# Railyards Specific Plan Update, KP Medical Center, MLS Stadium, & Stormwater Outfall

Final Subsequent Environmental Impact Report

P15-040 | SCH No. 2006032058

October 2016

**Figure 2-25**  
Illustrative Site Plan: KP Medical Center - Phase 2

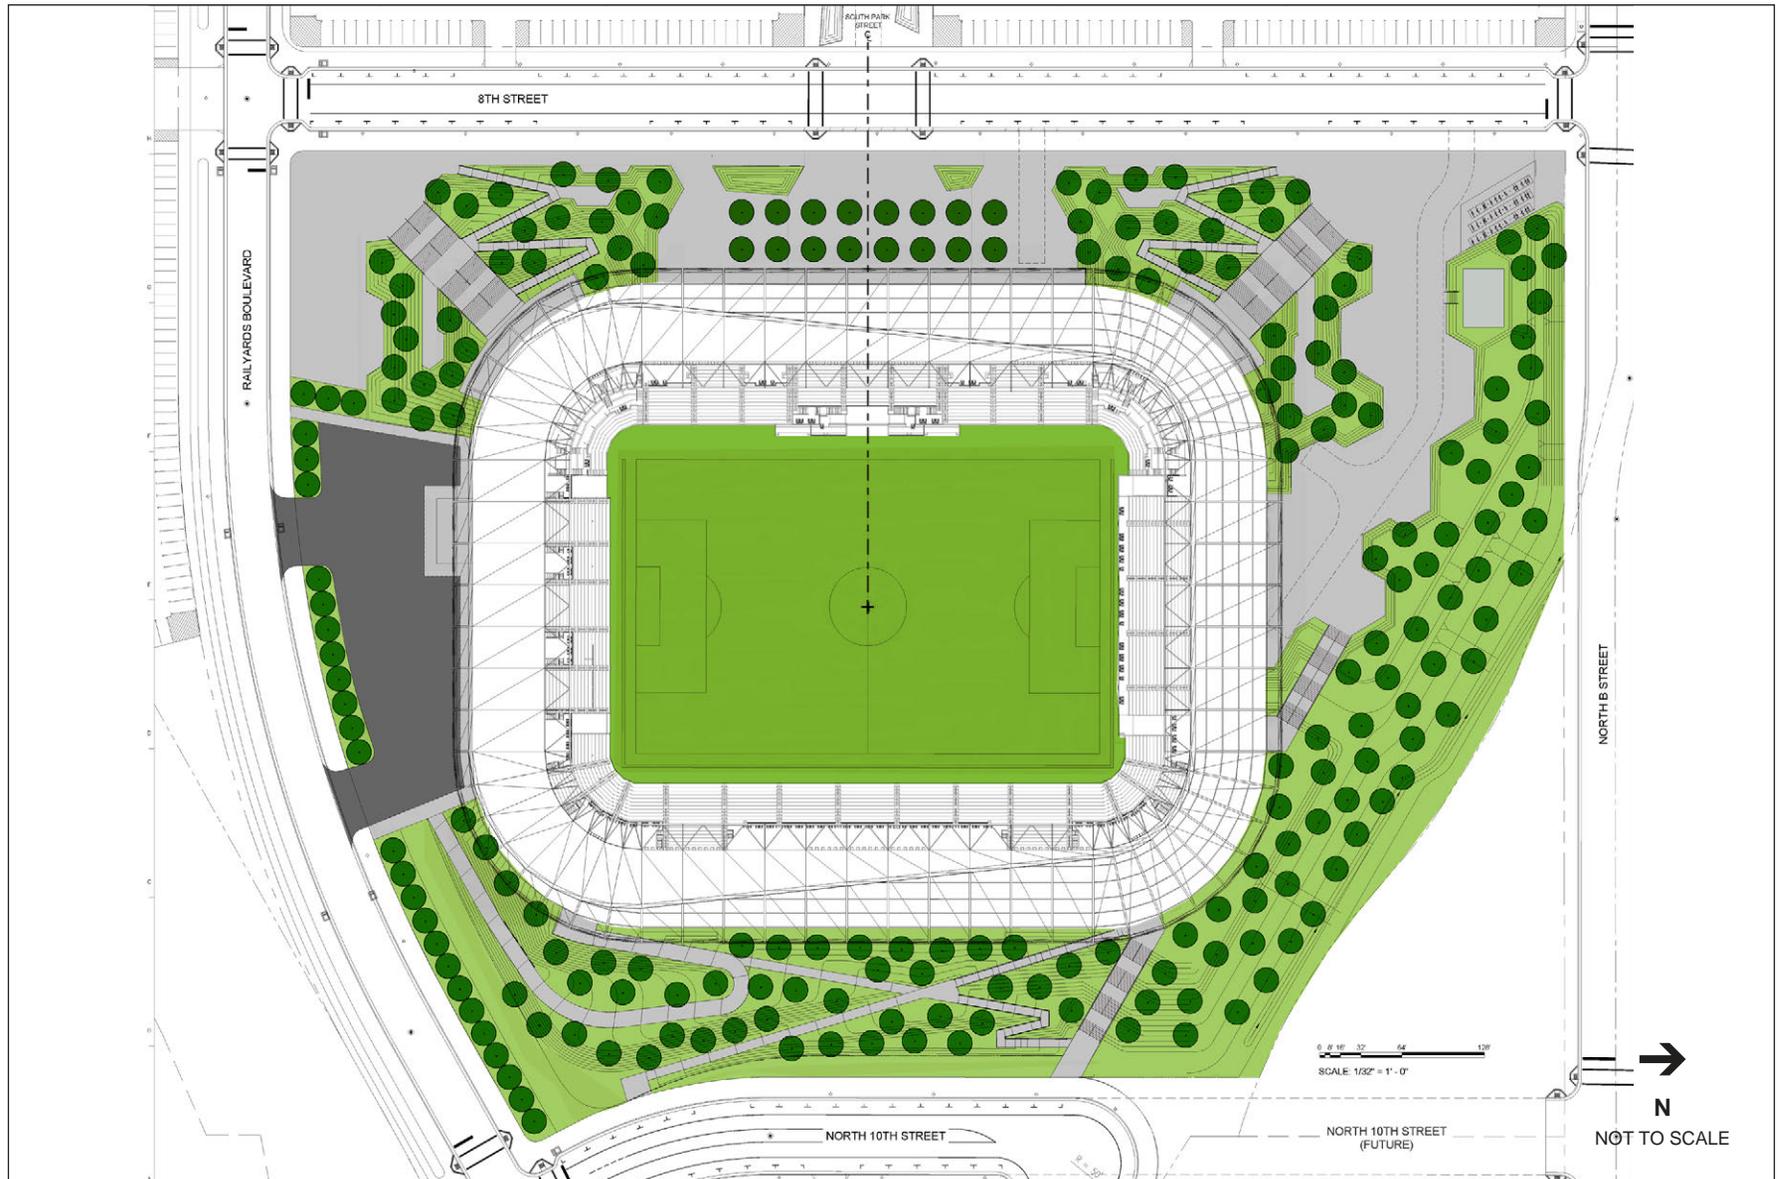
Figure 2-25, Illustrative Site Plan: KP Medical Center - Phase 2, is revised to reflect that there are two potential helistop locations for the KP Medical Center. One location could be at ground-level south of South Park Drive, and the other potential location could be on top of the hospital tower.

**Figure 2-28**  
Major League Soccer Stadium Conceptual Site Plan

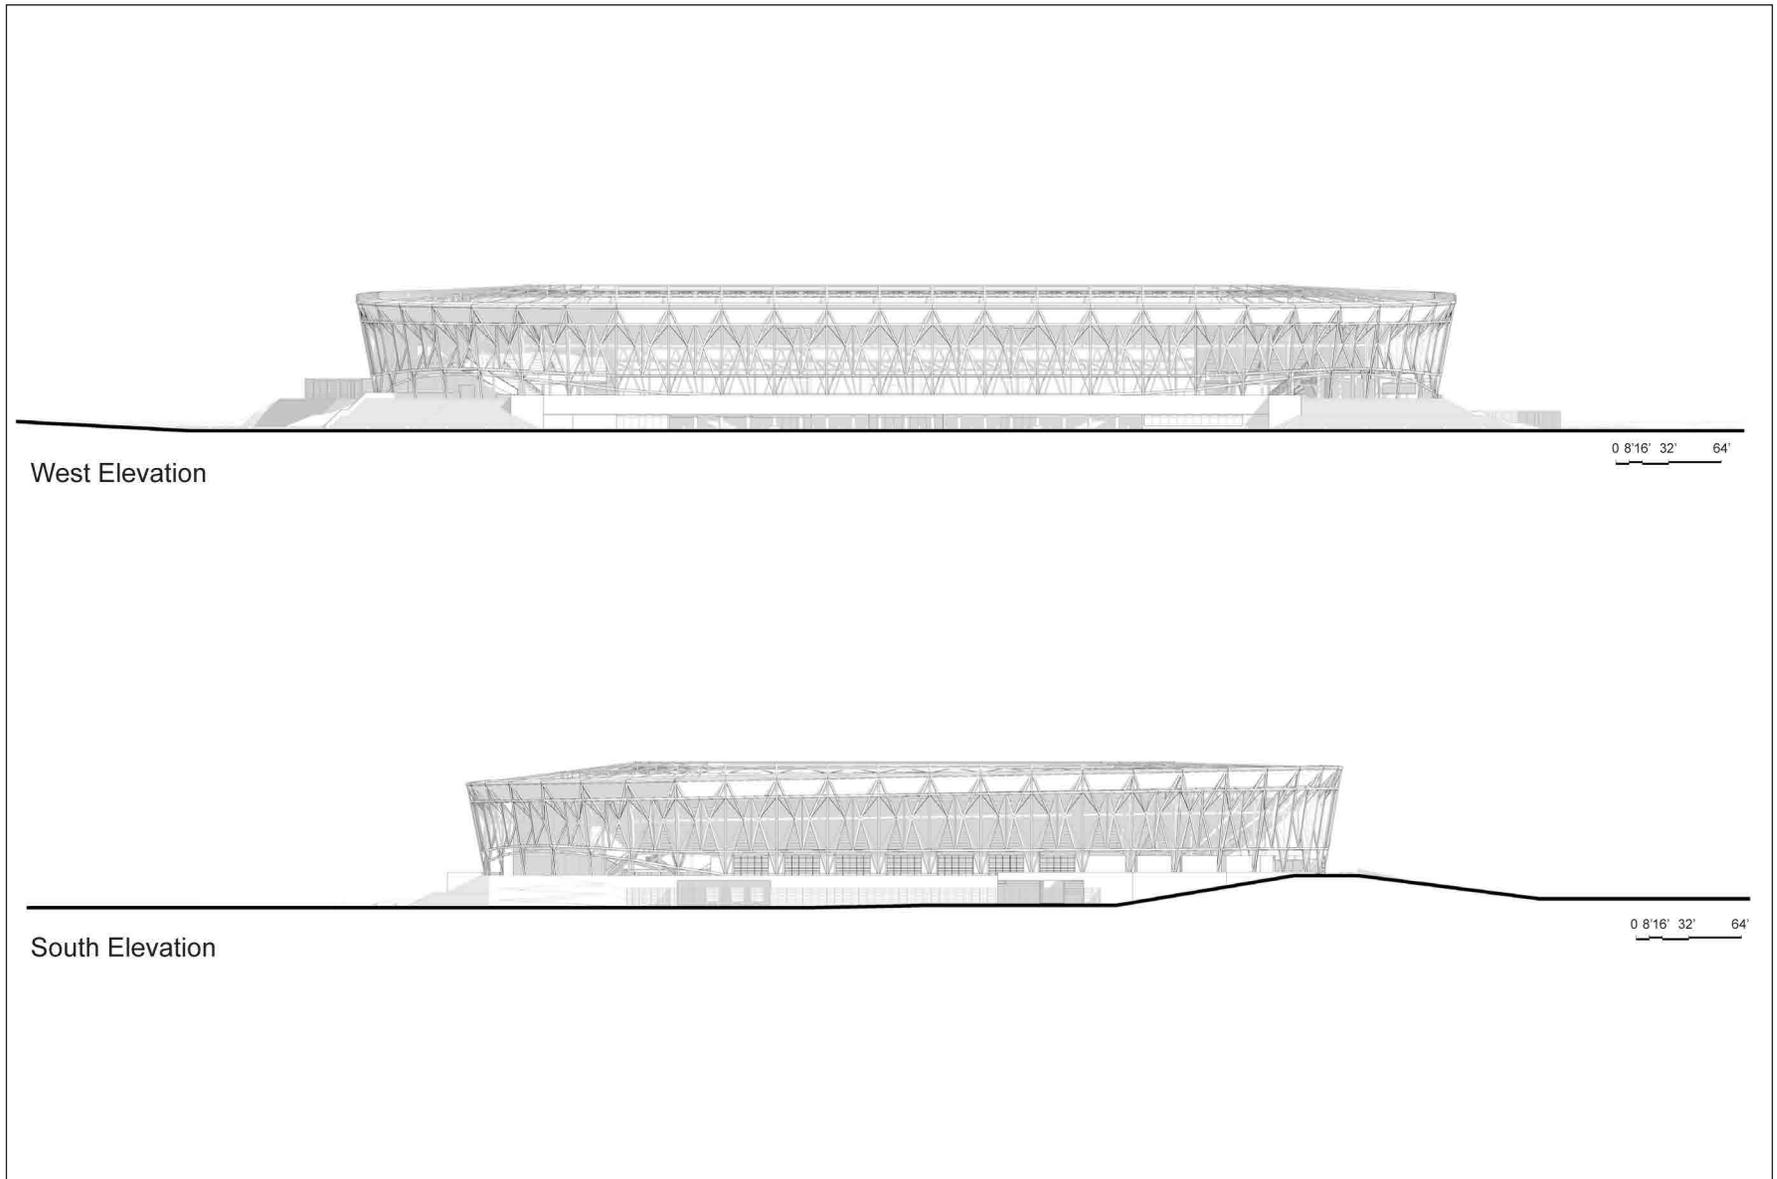
Figure 2-28, Major League Soccer Stadium Conceptual Site Plan, is revised to show the revised MLS Stadium location moved approximately 40 feet to the north.

**Figure 2-29**

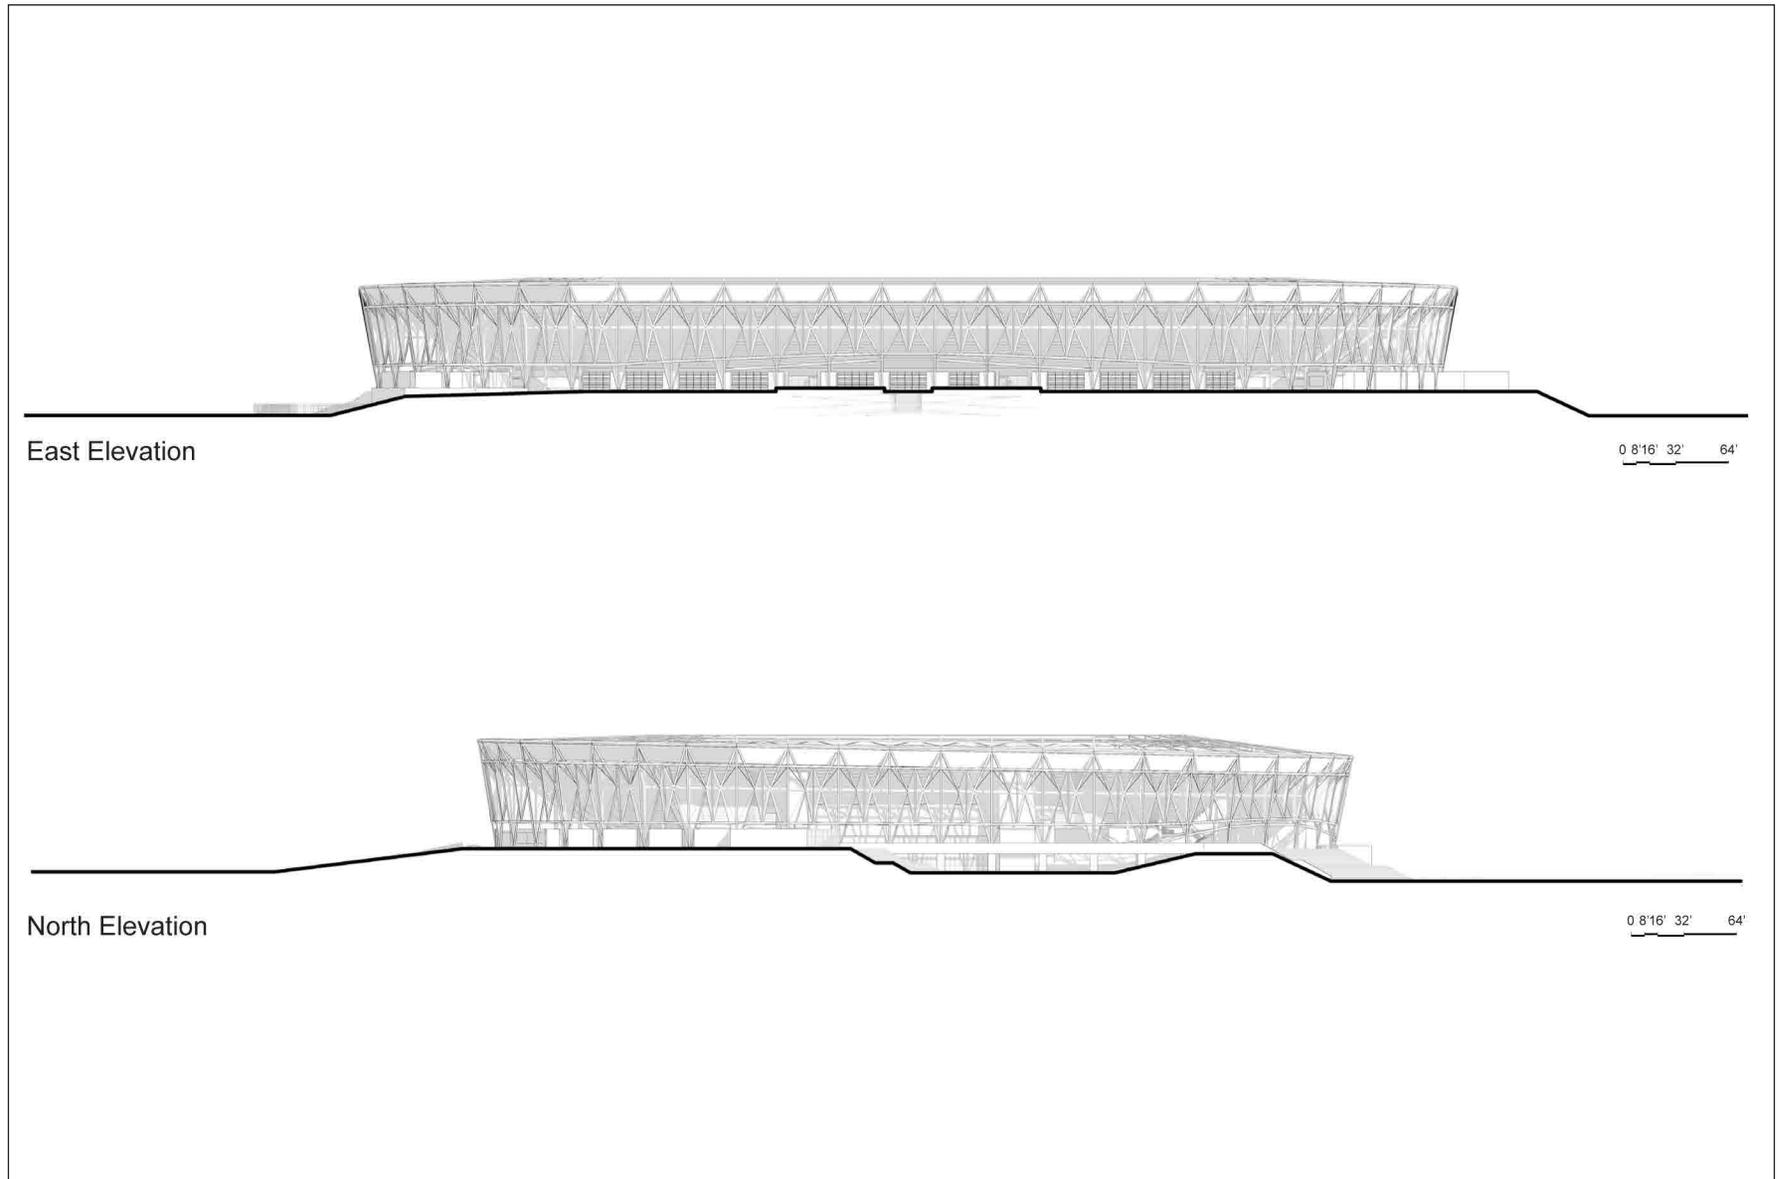
Figure 2-29, Stadium West (8th Street/Entry Plaza) Elevation, Stadium South (Railyards Boulevard) Elevation, is revised to show the revised MLS Stadium location moved approximately 40 feet to the north.

**Figure 2-30**  
Stadium East (10th Street) Elevation, North Elevation

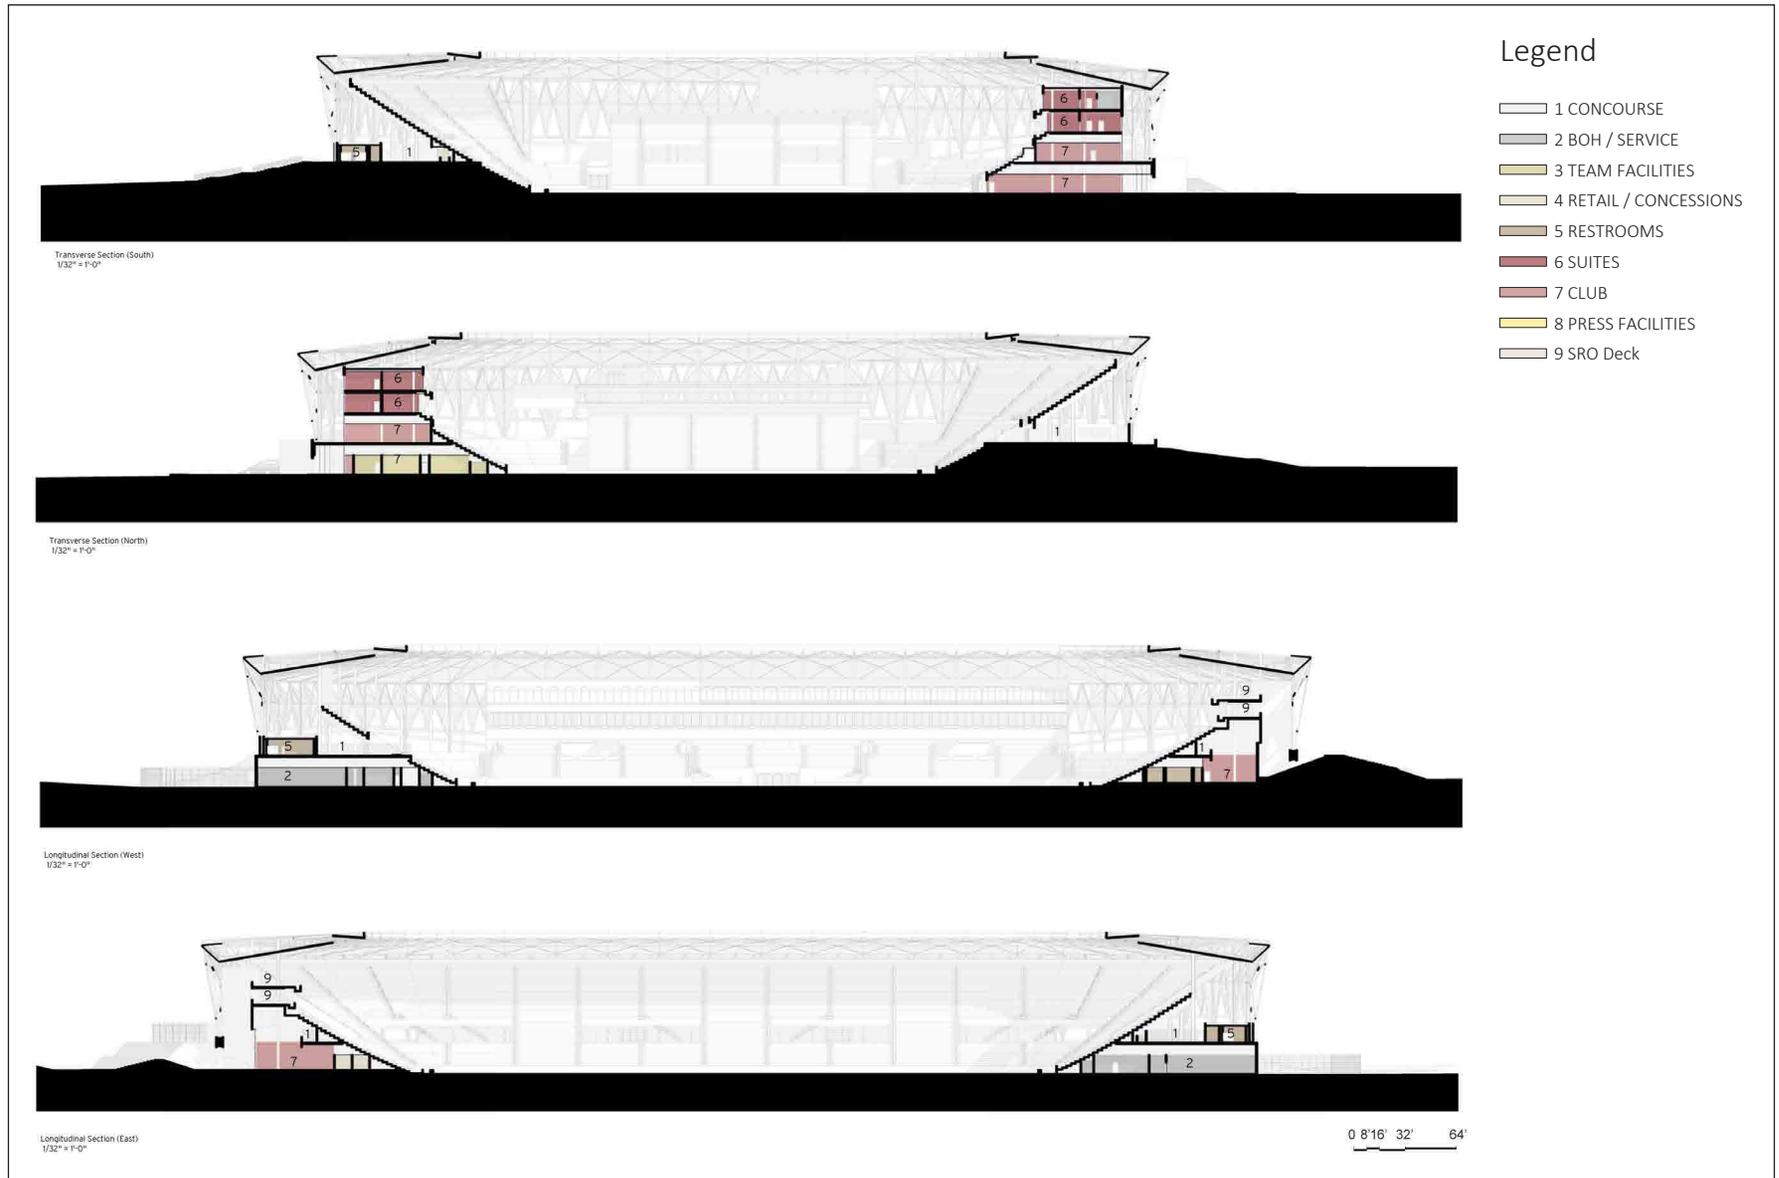
Figure 2-30, Stadium East (10<sup>th</sup> Street) Elevation, North Elevation, is revised to show the revised MLS Stadium location moved approximately 40 feet to the north.

**Figure 2-31**

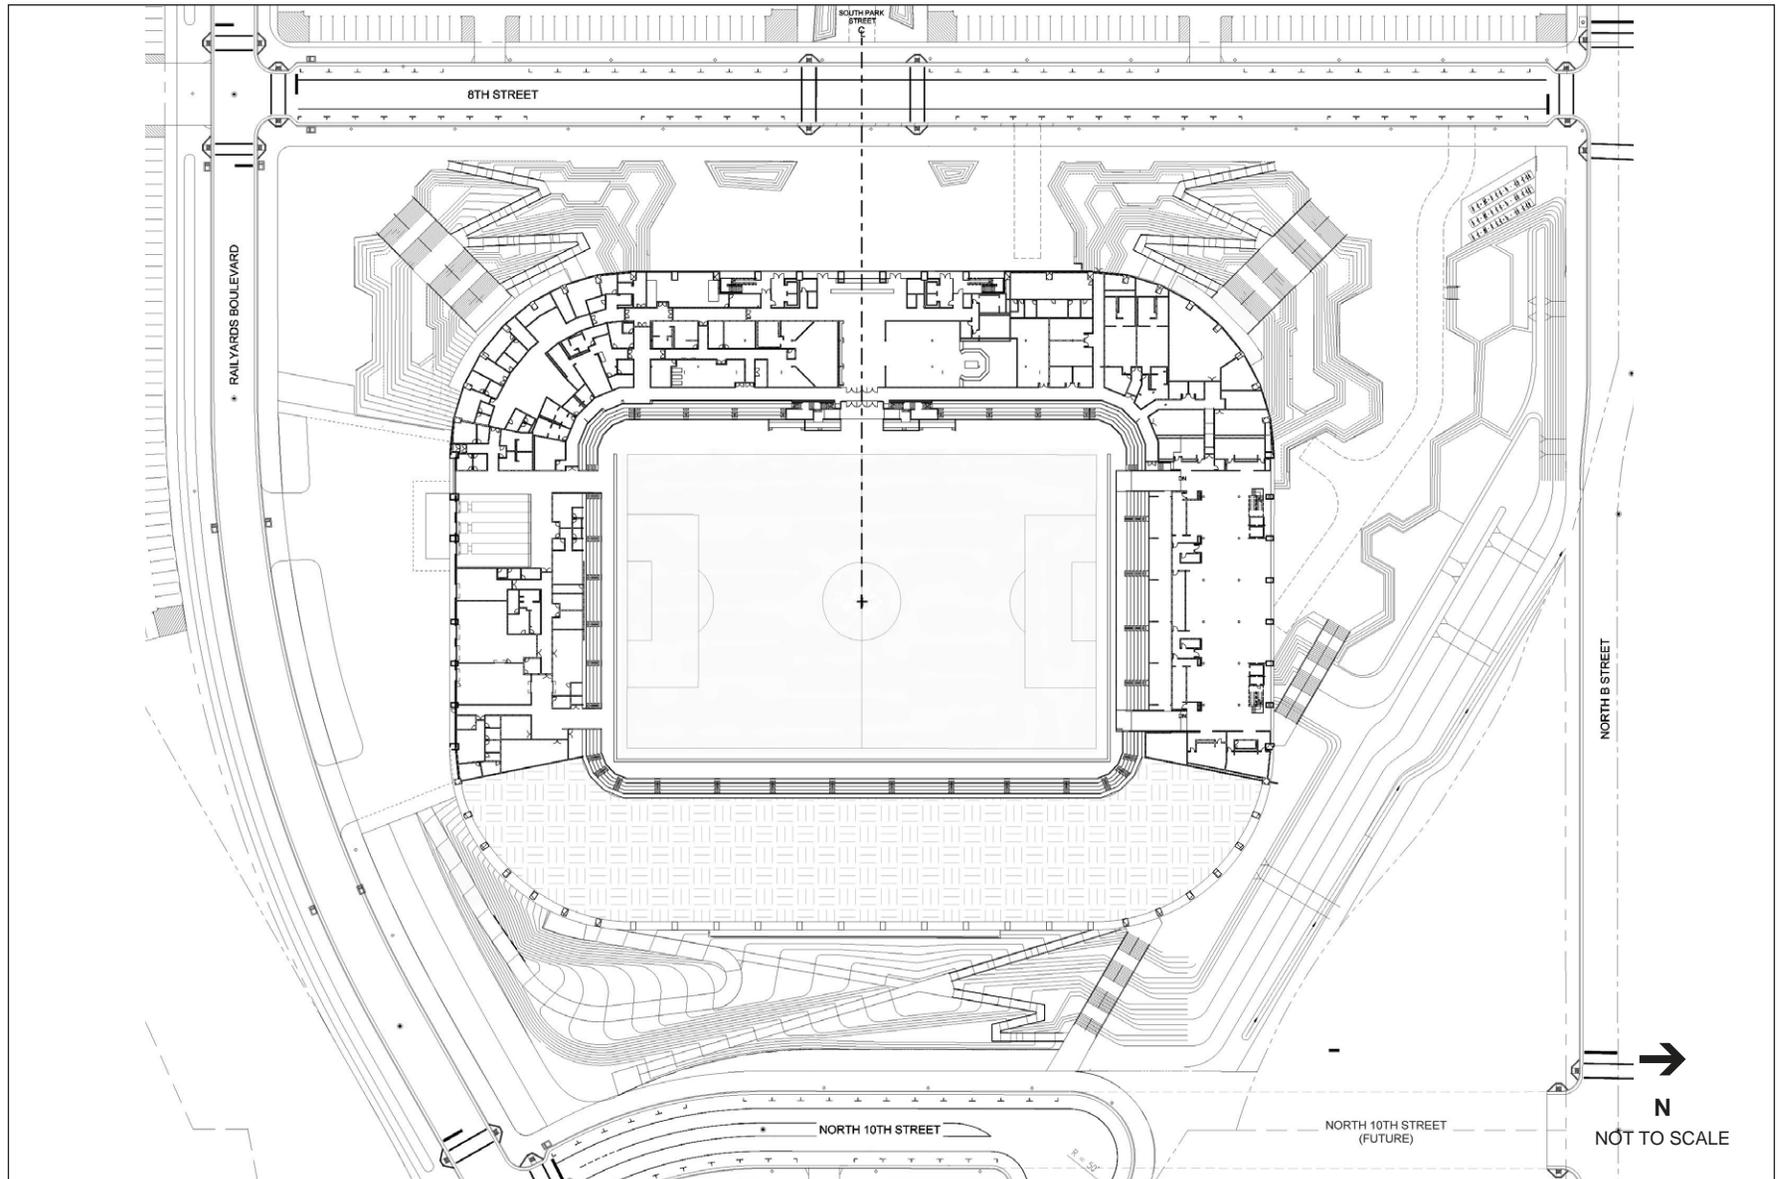
Figure 2-31, Stadium Longitudinal Building Sections, Transverse Building Sections, is revised to show the revised MLS Stadium location moved approximately 40 feet to the north.
